From: Polly Harris-Gorf
Sent: 13 May 2019 10:44
To: _planningadvice
Subject: H16-0266-19 LABURNUM LODGE 40 SPALDING COMMON
Attachments: Mimecast Attachment Protection Instructions; CCF10052019.pdf

Erection of detached bungalow - plot 1 (Outline approval H16-1000-16).

Laburnum Lodge | 40 Spalding Common | Spalding

Site Block Plan

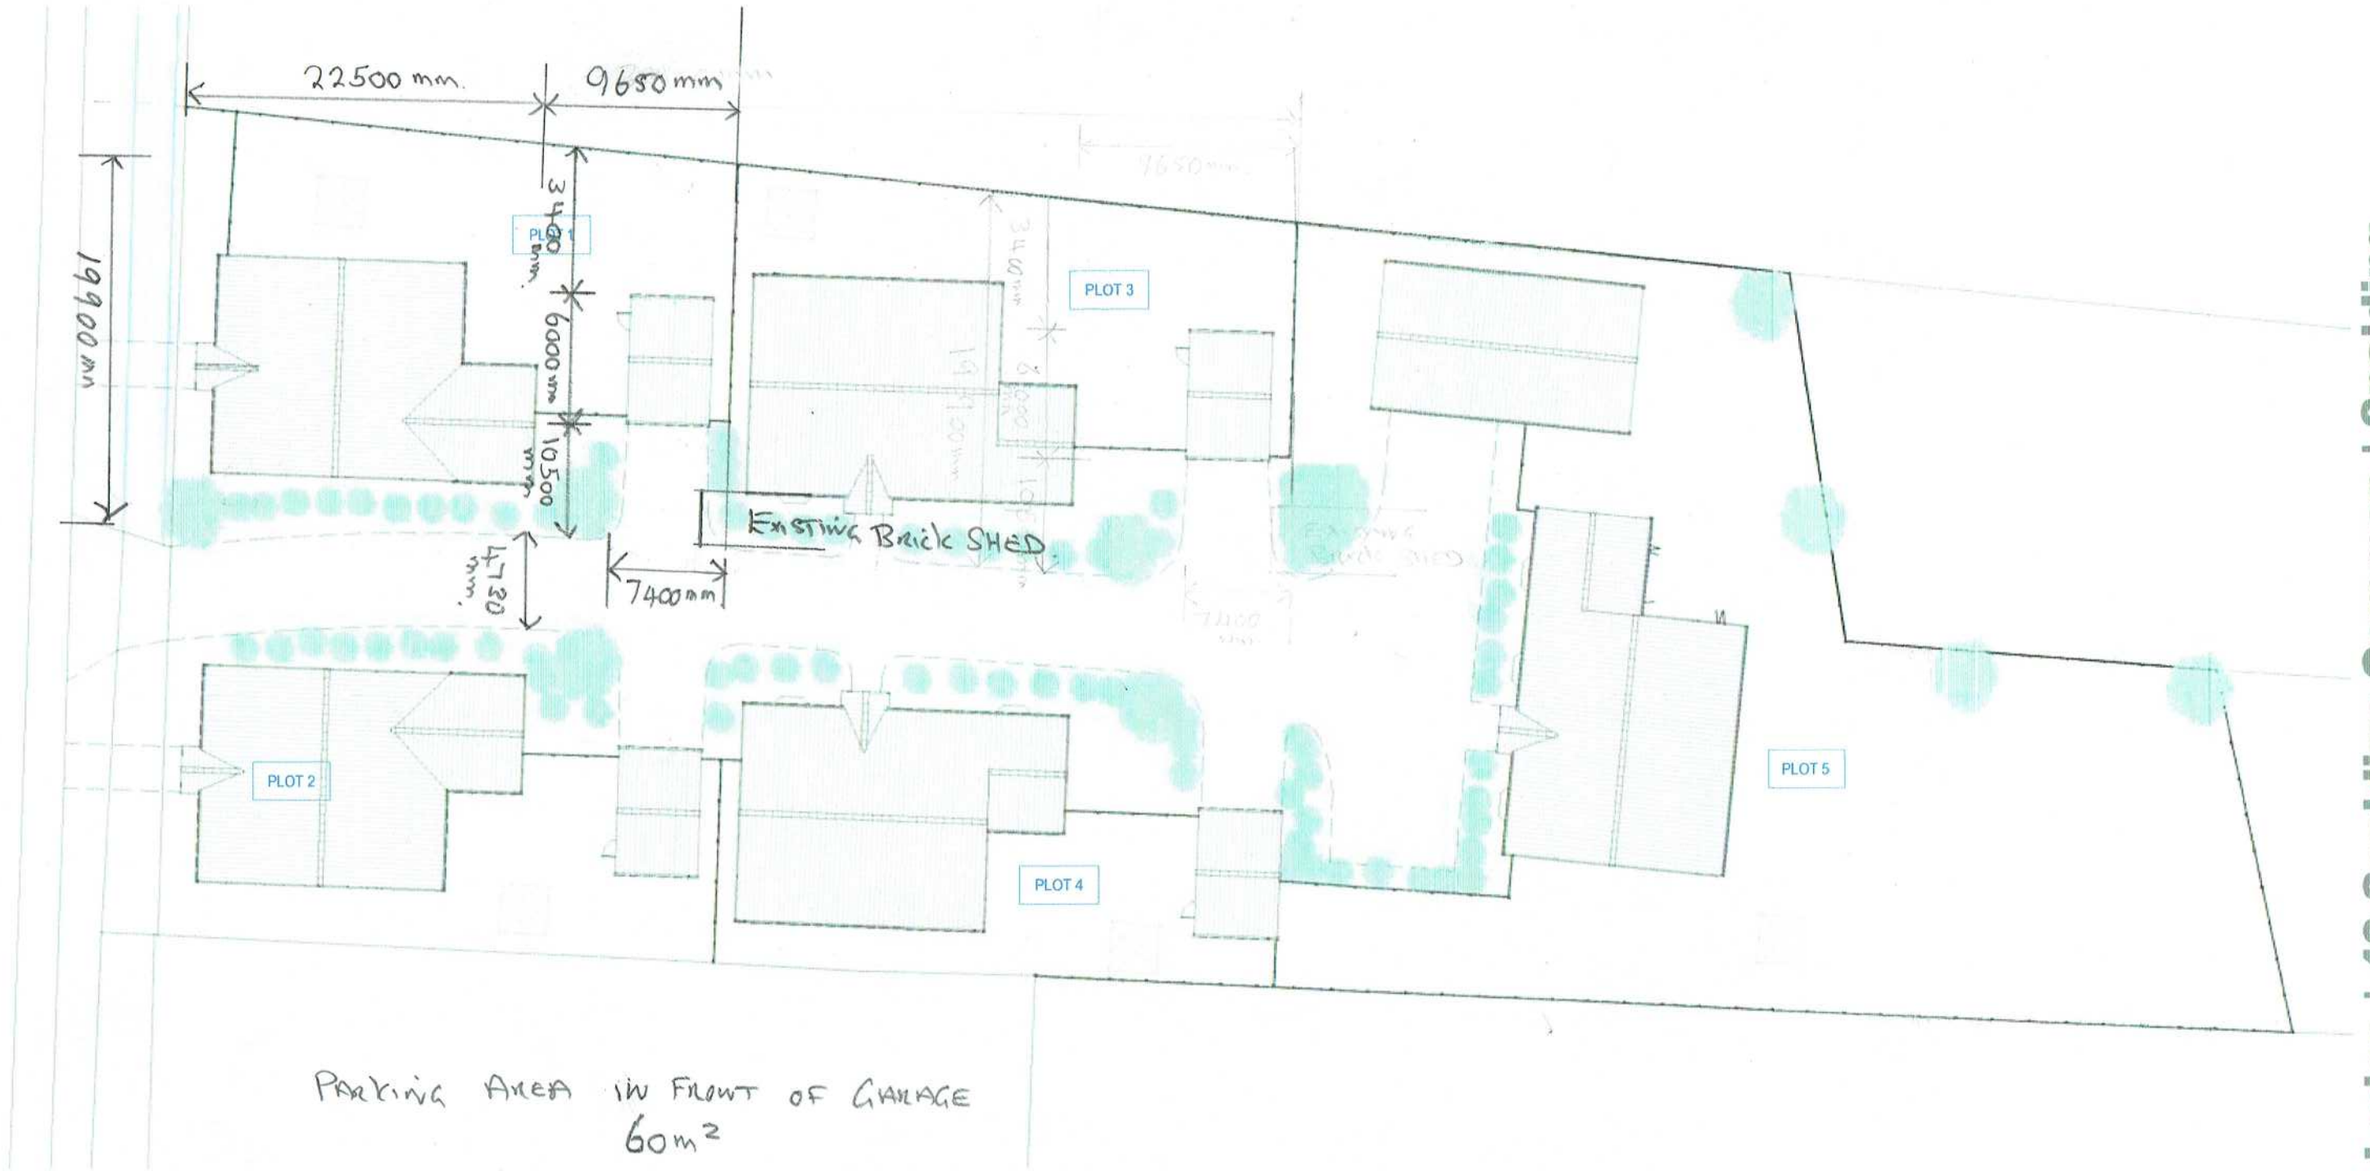
Please provide details of a means of storage and disposal of refuse and recycling as part of the decision notice (point 5) for the outline approval H16-1000-16.

Please also provide a scaled layout drawing showing the minimum width of the proposed shared access. The minimum width must be 4.1m.

Please also provide details of the parking arrangements with measurments. A minimum of two parking spaces must be provided for a dwelling with up to three bedrooms. A garage plus the space immediately in front of it will count as one space, two spaces only when the garage is of adequate size to allow for car parking and general storage.

Please find attached plan showing dimension of plot 1 40 Spalding common

Means for disposal of storage of refuse will be plastic bags stored within the plot 1 boundaries and put out on the day of collection at the front of property on the verge

The shared driveway is 4.730 mtrs wide and there will be approximately 7.4 mtrs x 10.5 mtrs in front of the new garage for parking of vechicles.

Parking Area in Front of Garage
60m²

Width of Drive
4.730mm
